**FRONTEER WIND FARM, EASTERN CAPE PROVINCE
(DFFE Reference No.: 14/12/16/3/3/1/2315)**

COMMENTS AND RESPONSES REPORT

No.	Comment	Raised by	Response																																																		
			<p>Appendix 2. Figure 1. Martial Eagle flight density and distance from the nest, Choje West June 2019 - August 2020 (mean \pm 95% confidence limits).</p>

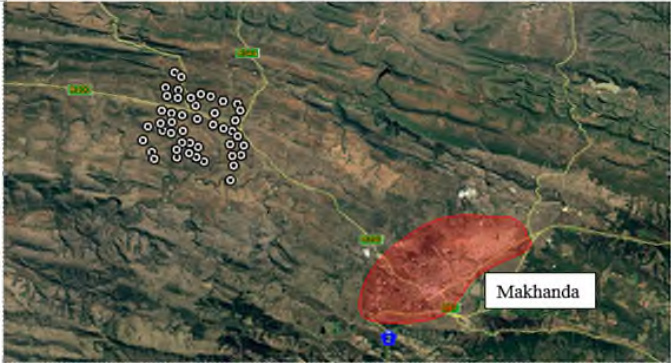
No.	Comment	Raised by	Response
	<p>7. The proposed buffers for Martial Eagle nests are also significantly less than recommended in most other impact assessments (i.e. 5-6 km). Van Eeden et al. (2017) 's research tracking Martial Eagles in the Kruger indicated a 50% Kernel Density with an average of 16.5km² - which would suggest a buffer with a radius of 2.9 km from a nest would be necessary to avoid just the core territory. Martial Eagle territories are likely to be much larger in the area of the proposed development.</p>		<p>This follows on from the same principle as above, where Murgatroyd et al highlighted the limited benefit of simple circular buffers and their inefficiency in defining areas of higher collision risk, as these eagles do not randomly move around a specific distance from their nests but choose to forage and fly over specific areas and habitats within their range. The spatial modelling undertaken by the specialist has shown the importance of distance from the nest, but also altitude (higher flight activity in the 600-800m range), distance from ridge lines (higher closer to ridge lines), and slope (higher in areas of steeper slope).</p> <p>In relation to the design of the site buffers, the analysis used to inform the 2.5km distance for Martial Eagle is set out in Appendix 2 of the AIA (Appendix E of the BAR). Figure 1 from that appendix is reproduced here as it illustrates the evidence base for the use of that specific distance. The survey data showed a strong relationship between flight density and distance from the nest, but this relationship flattened out beyond 2.5km. The highest densities were recorded within 500m of nests and there was a steady decline in flight density with distance from the nest, but only up to a distance of 2.5km. Beyond 2.5km flight density was consistently lower. A ny exclusion of turbines beyond 2.5km would be of much less benefit in reducing collision risk. A similar result was found for the Choje East Block, though there, higher flight activity was noted within 1.5km of the nest (though with a smaller amount of baseline data available a precautionary approach was adopted and a 2.5km applied in the East and as well as the West).</p>

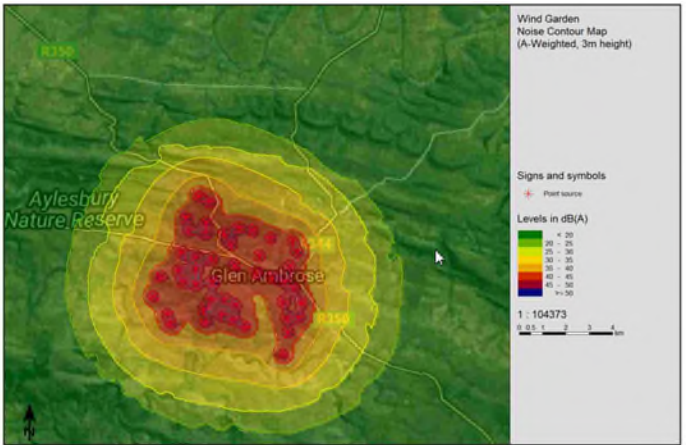
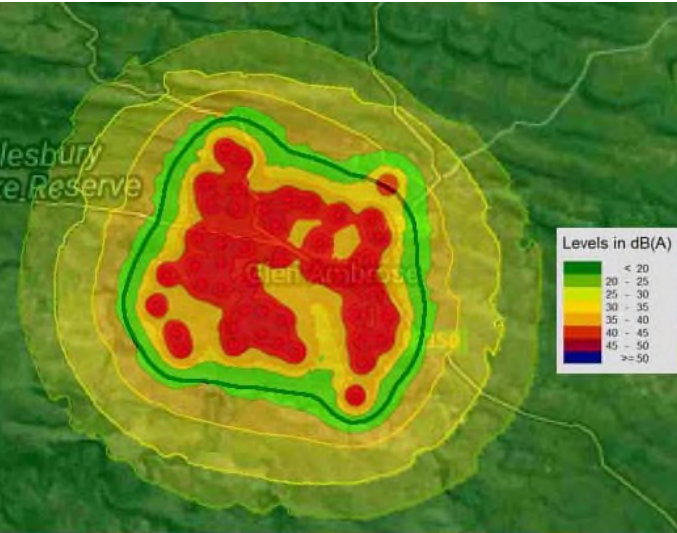
b) Thus the reading of existing noise levels must be repeated		This statement is not correct as responded to and highlighted in the above-mentioned response.
	<p>2.5. Ad Figure 8-4</p> <p>2.5.1. The above figure shows a noise contour map, as per below:</p>		The Figure from Machoy is duplicated below, with the 35 dBA contour highlighted by the author in black. Overlaid on this Figure are the contours developed by the author, using the German software SoundPlan Essentials, purchased

2.5.2	<p>The Figure 8.4 map and the SoundPlan map differ in many respects:</p>		<p>Please refer to the above-mentioned response.</p>

No.	Comment	Raised by	Response
	a) Sound levels in the Figure 8.4 map are not the same as the SoundPlan Map. b) The contour shapes differ.		
	2.5.3. On this basis it must be concluded that the Figure 8.4 map is not computer generated and is thus incorrect.		The statement of Machoy that the contours are not computer generated is disingenuous.
	2.6. Ad. Appendix E: Photos of Measurement Locations 2.6.1. Photographs are provided of measurement locations. These are as follows:  <p>Photo B.1: Measurement location at WRL TSL01</p>		This is a statement. No response is required.

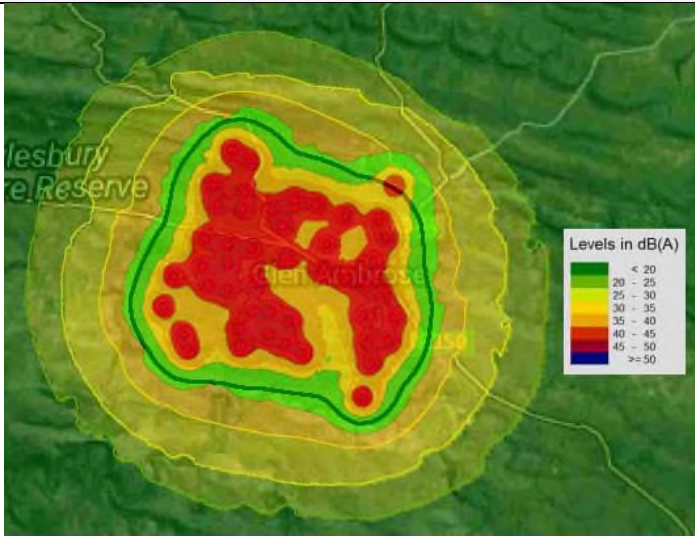
No.	Comment	Raised by	Response
	 <p data-bbox="232 651 589 671">Photo B.5: Measurement location at WRLTSL05</p> <p data-bbox="232 676 477 697">2.6.2. It is noted that:</p> <p data-bbox="232 746 1014 842">a) In paragraph 2.4.4 above it is noted none of the measurement locations is at an identified noise sensitive location or with in the WEF area.</p> <p data-bbox="277 890 1014 1233">In SANS 10103:2008 "The measurement and rating of environmental noise with respect to land use, health, annoyance and to speech communication" it specifically states that "At each measuring point, the microphone should be placed at a height of between 1,2 m and 1,5 m for general investigations, and, if practicable, at least 3,5 m away from walls, buildings and other large flat vertical surfaces." It is clear that from photographs B3 and B4 that the microphones are less than 3,5 m from "walls, buildings and other large flat vertical surfaces" and consequently these measurements are not valid.</p>		<p data-bbox="1404 676 2101 1337">As highlighted by SANS 10103:2008 (underlined and bolded by the author), "the microphone should be placed at a height of between 1,2 m and 1,5 m for general investigations, and, if practicable, at least 3,5 m away from walls, buildings and other large flat vertical surfaces". When this is not possible, the data can be adjusted (reduced) with a value between 1 and 6 dBA (due to reflections from the flat surfaces). On this project the microphone was at 1.3 m, and, placed at locations to ensure that the equipment is safe, secure and will provide data that are not unduly influenced by the surrounding environment. At two locations this was not possible, due to numerous reasons. The author however did not adjust the data because: - At location WRLTSL03 the influence of the wall was much lower than the microphone and the influence of the wall was considered to be minimal; and - At location WRLTSL04 the wall is uneven with large openings, with the surface behind it well vegetated. The wall is more likely to act as a diffuser than a reflecting wall.</p>

Appendix 2. Figure 1. Martial Eagle flight density and distance from the nest, Choje West June 2019 - August 2020 (mean \pm 95% confidence limits).

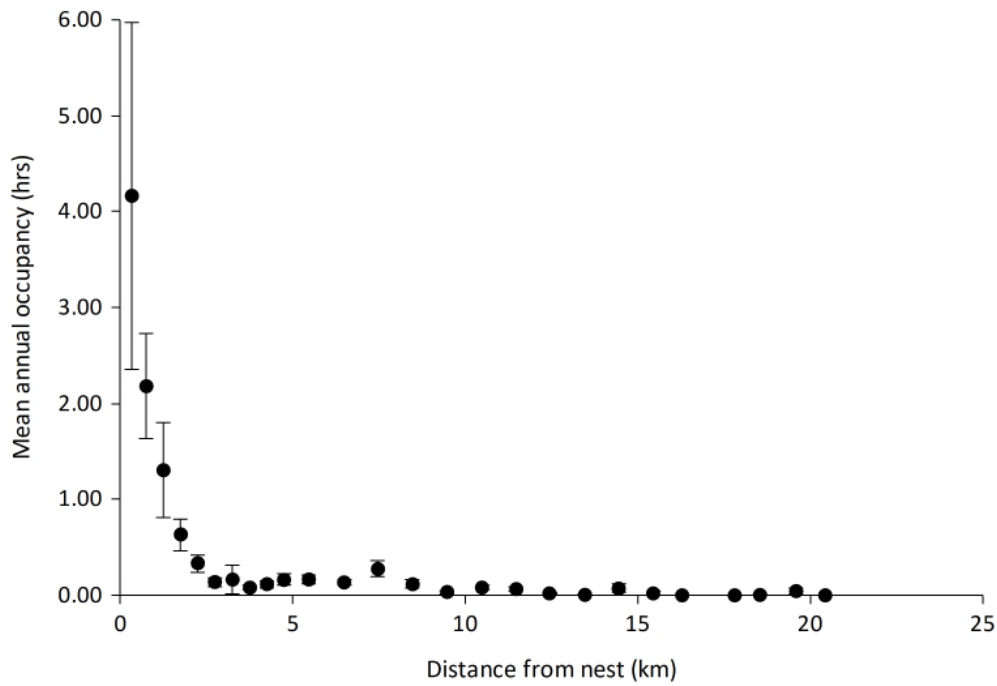
Concerns are raised about the amount of VP data. There has though been a very considerable amount of surveys (900 hours over the Wind Garden/Fronteer study area as a whole, i.e. the area indicated in Figure 3 of the report). The lack of records flying through the collision risk zone was not a result of a lack of survey effort but rather reflect the very low use that these species made of the zone.

Assertions about the quality of VP data ignore the fact that this is a well-proven methodology that has been adopted worldwide to assist in wind farm collision risk analysis. To describe rigorously collected VP data as ‘notoriously unreliable’ is at best disingenuous, if not misleading.

In relation to the design of the site buffers, the analysis used to inform the 2.5km distance for Martial Eagle is set out in Appendix 2. Figure 1 from that appendix is reproduced here as it illustrates the evidence base for the use of that specific distance. The survey data showed a strong relationship between flight density and distance from the nest, but this relationship flattened out beyond 2.5km. The highest densities were recorded within 500m of nests and there was a steady decline in flight density with distance from the nest, but only up to a distance of 2.5km. Beyond 2.5km flight density was consistently lower. Any exclusion of turbines beyond 2.5km would be of much less benefit in reducing collision risk. A similar result was found for the Choje East Block, though there, higher flight activity was noted within 1.5km of the nest (though with a smaller amount of baseline data available a precautionary approach was adopted and a 2.5km applied in

Figure 1: Choje East - Proximity to roads.

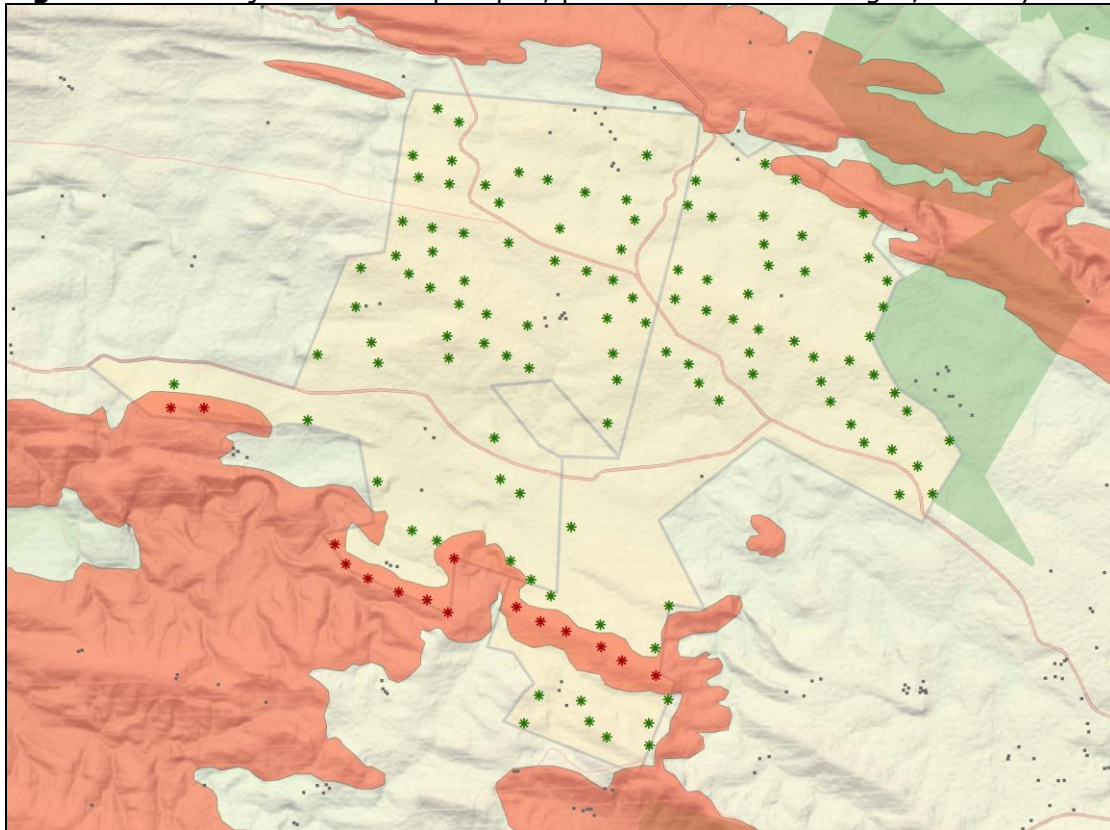
29 turbine positions (indicated in red) are located within 500m from major roads.

Figure 2: Choje East - Steep slopes, prominent hills and ridges, and skylines.

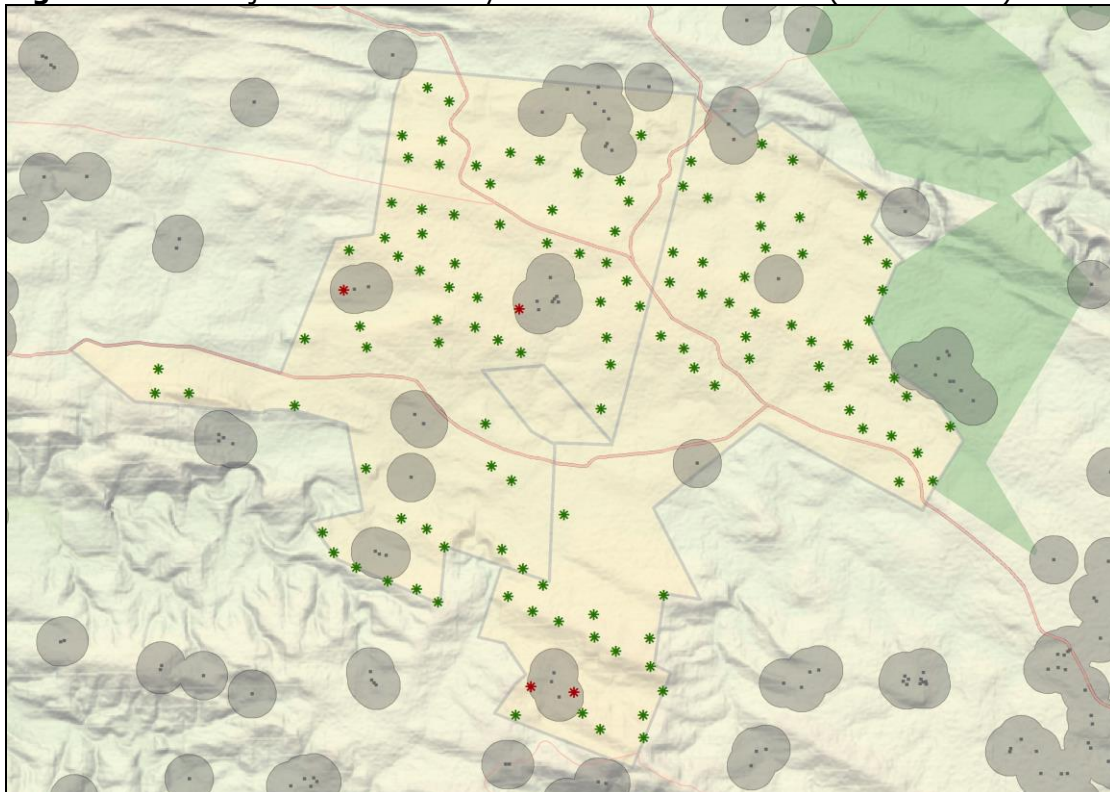
15 turbines are located on exposed topographical units.

Figure 3: Choje East - Proximity to inhabited residences (homesteads).

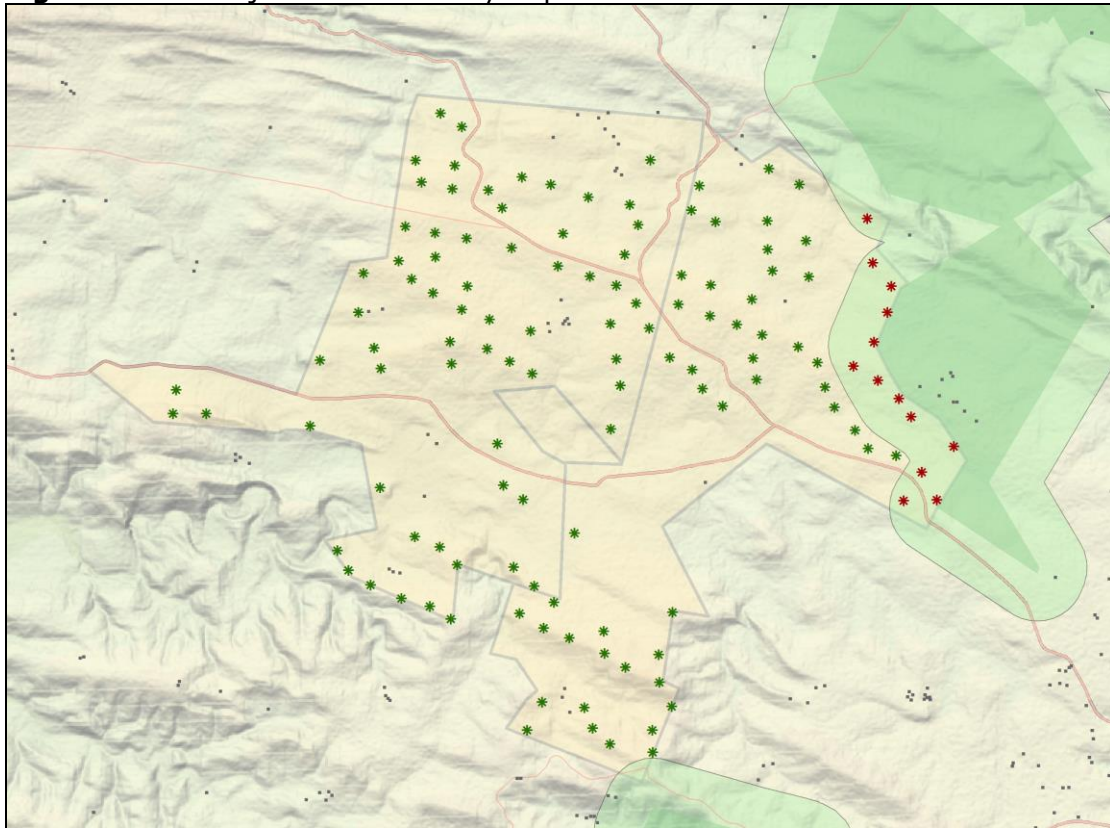
4 turbine positions are located within 500m from homesteads.

Figure 4: Choje East - Proximity to protected areas and tourist attractions.

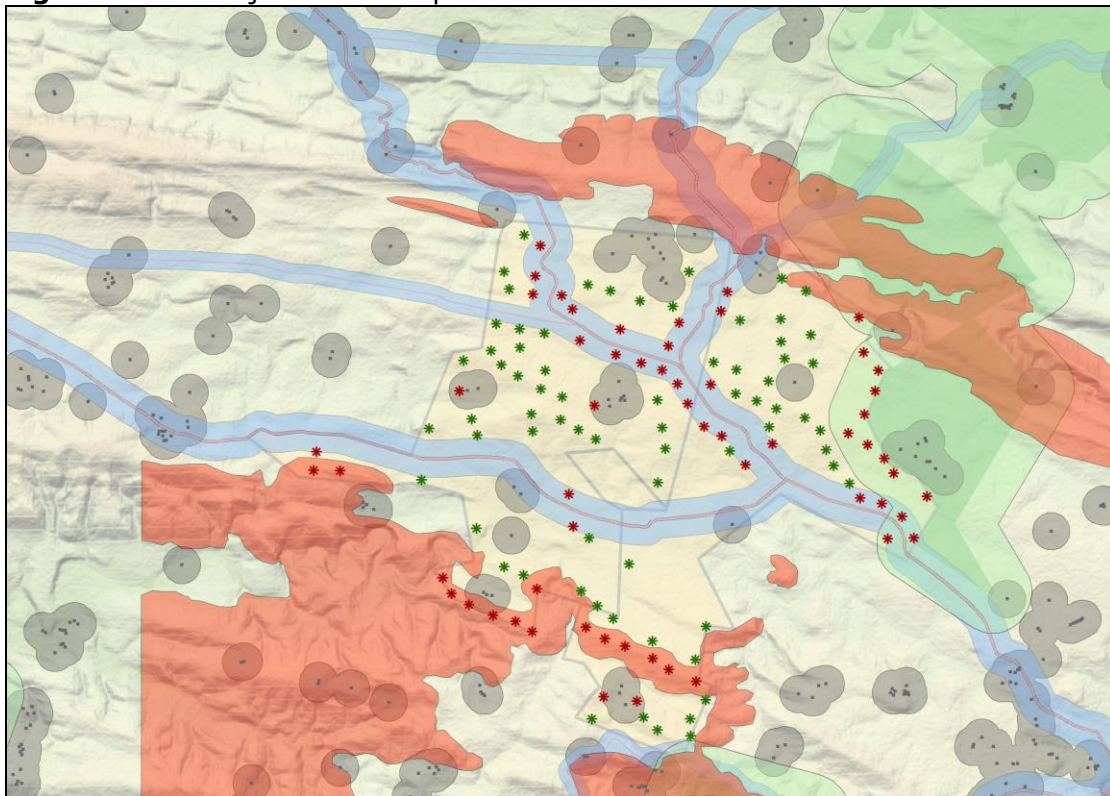
13 turbine positions are located within 1km from a nature reserve.

Figure 5: Choje East - Composite of all criteria.

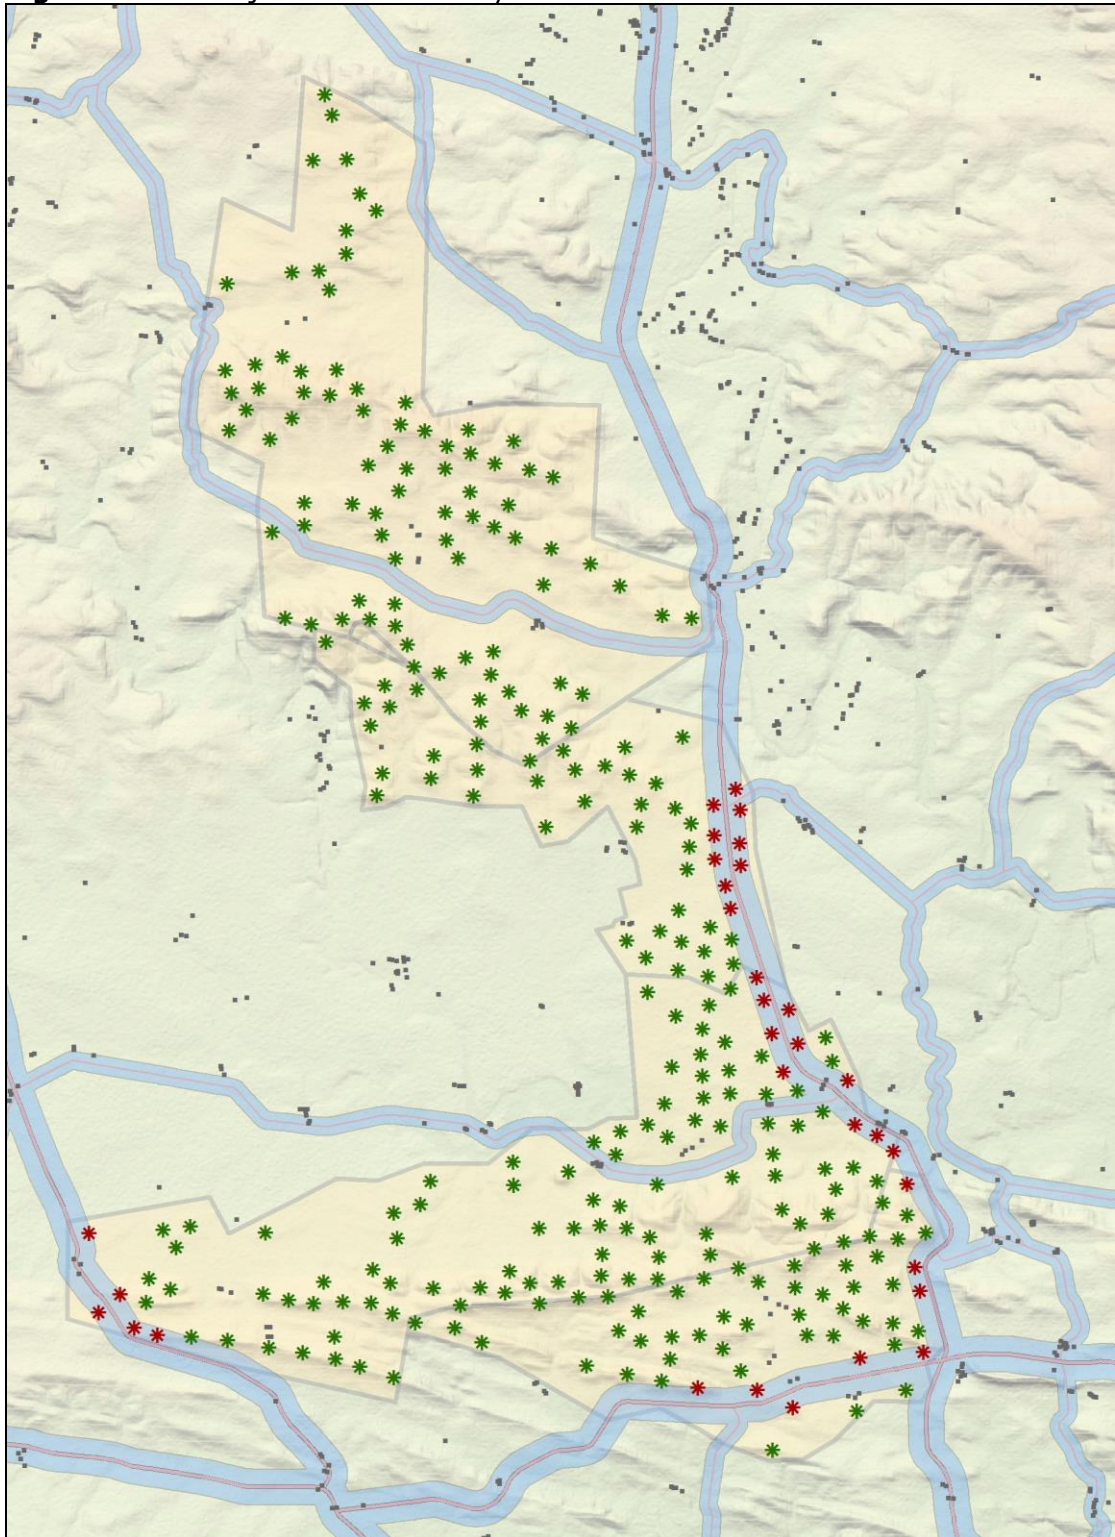
A total number of **58** (out of 128) turbine positions fall within the advised thresholds.

Figure 6: Choje West - Proximity to roads.

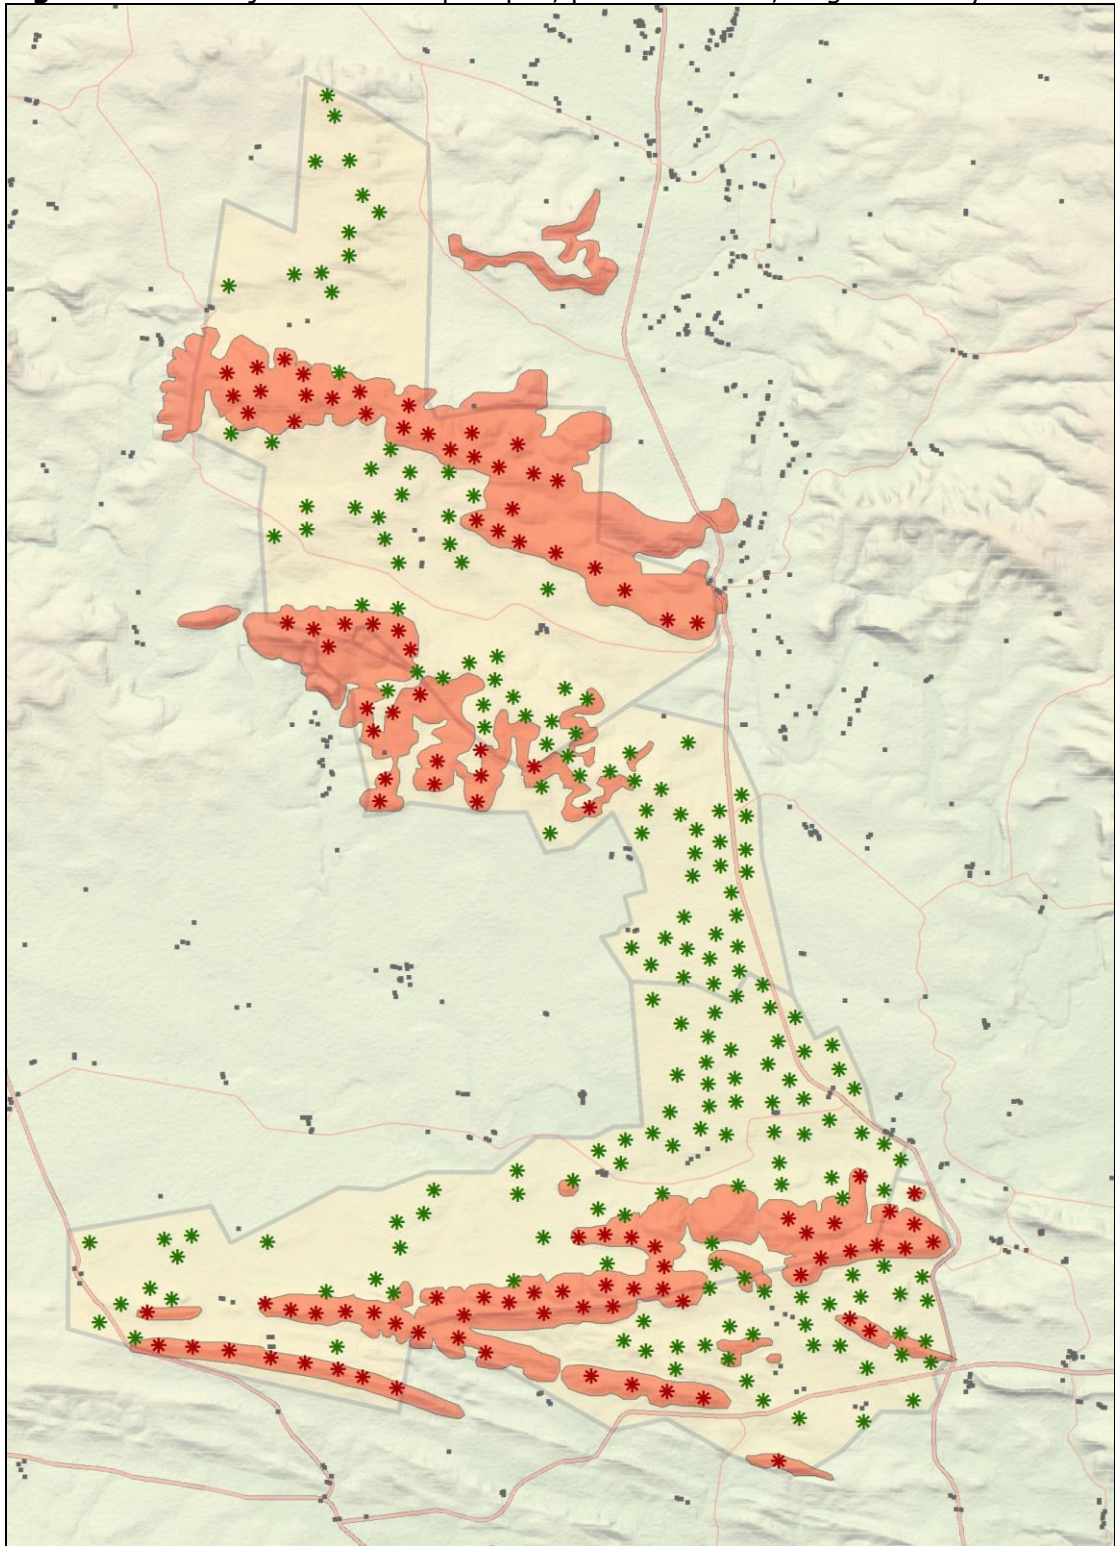
27 turbine positions (indicated in red) are located within 500m from major roads.
